**PCN#20150904001
Carrier Tape Change for Selected SC70 Packaged Devices
Final Change Notification**

PCN Number:	20150904001	PCN Date:	09/29/2015
Title:	Carrier Tape Change for Selected SC70 Packaged Devices		
Customer Contact:	PCN Manager	Dept:	Quality Services
Proposed 1st Ship Date:	12/29/2015		
Change Type:			
☐ Assembly Site	☐ Assembly Process	☐ Assembly Materials	
☐ Design	☐ Electrical Specification	☐ Mechanical Specification	
☐ Test Site	☒ Packing/Shipping/Labeling	☐ Test Process	
☐ Wafer Bump Site	☐ Wafer Bump Material	☐ Wafer Bump Process	
☐ Wafer Fab Site	☐ Wafer Fab Materials	☐ Wafer Fab Process	
	☐ Part number change

New Carrier tape Dimensions:

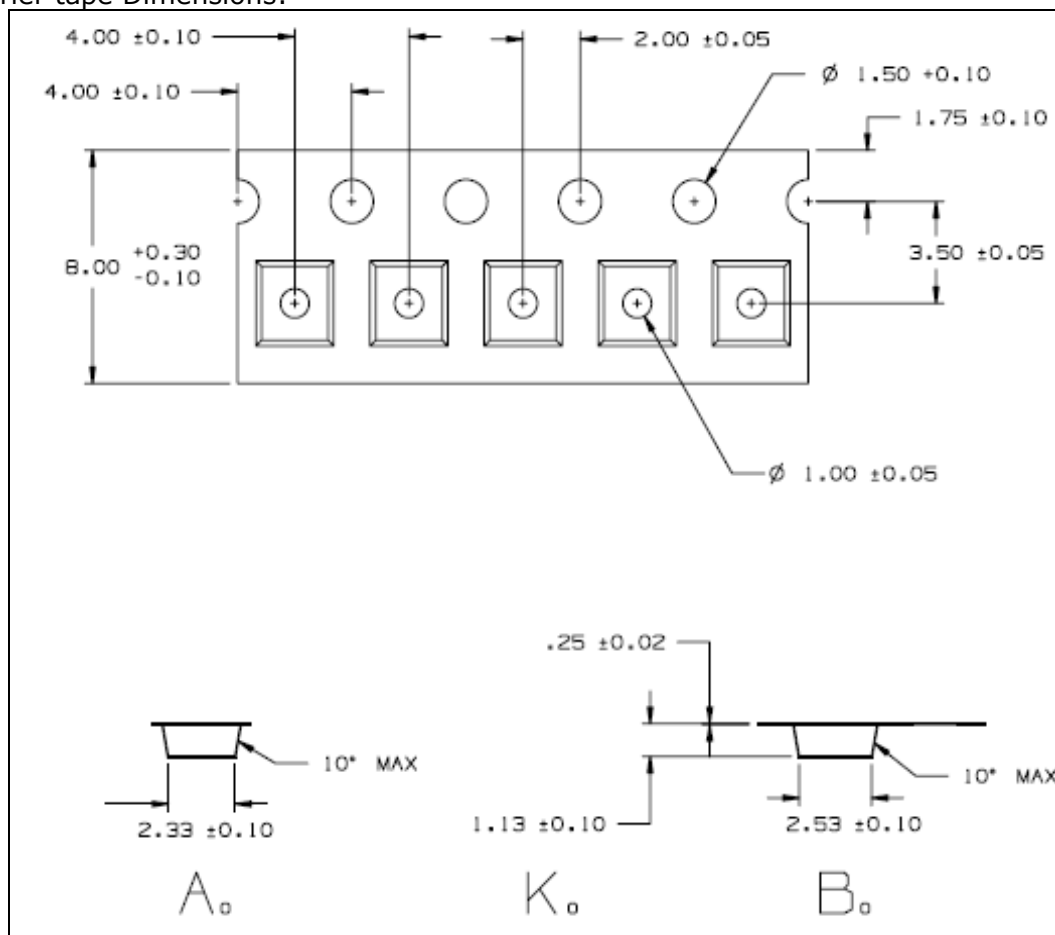
Texas Instruments is pleased to announce the qualification of a new carrier tape for selected devices in the SC70 package. The material composition between the 2 carrier tapes is the same. A dimensional comparison summary is below:

Dimension	From	To
Ao	2.25 (+/- 0.1) mm	2.33 (+/- 0.1) mm
Bo	2.40 (+/- 0.1) mm	2.53 (+/- 0.1) mm
Ko	1.22 (+/- 0.1) mm	1.13 (+/- 0.1) mm

Reason for Change:			
Alignment with EIA 481 SC70 pocket dimensions			
Anticipated impact on Fit, Form, Function, Quality or Reliability (positive / negative):			
None			
Changes to product identification resulting from this PCN:			
New Carrier Tape			
Product Affected:			
SN74LVC1G00DCKJ	LM4040B10IDCKR	REF3320AIDCKT	TLVH431ACDCKT
SN74LVC1G00IDCKREP	LM4040B20IDCKR	REF3320AIDCKTG4	TLVH431ACDCKTG4
V62/04732-01XE	LM4040B20IDCKT	REF3325AIDCKR	TLVH431AIDCKR
SN74LVC1G00MDCKREP	LM4040B25IDCKR	REF3325AIDCKRG4	TLVH431AIDCKT
V62/04732-02XE	LM4040B25IDCKRG4	REF3325AIDCKT	TLVH431AQDCKR
SN74LVC1G08DCKJ	LM4040B30IDCKR	REF3325AIDCKTG4	TLVH431AQDCKT
SN74LVC1G08IDCKREP	LM4040B30IDCKRG4	REF3330AIDCKR	TLVH431BCDCKR
V62/04733-01XE	LM4040B41IDCKR	REF3330AIDCKRG4	TLVH431BCDCKT
SN74LVC1G08MDCKREP	LM4040B50IDCKR	REF3330AIDCKT	TLVH431BCDCKTG4
V62/04733-02XE	LM4040C10IDCKR	REF3330AIDCKTG4	TLVH431BIDCKR
SN74LVC1G125DCKJ	LM4040C20IDCKR	REF3333AIDCKR	TLVH431BIDCKRE4
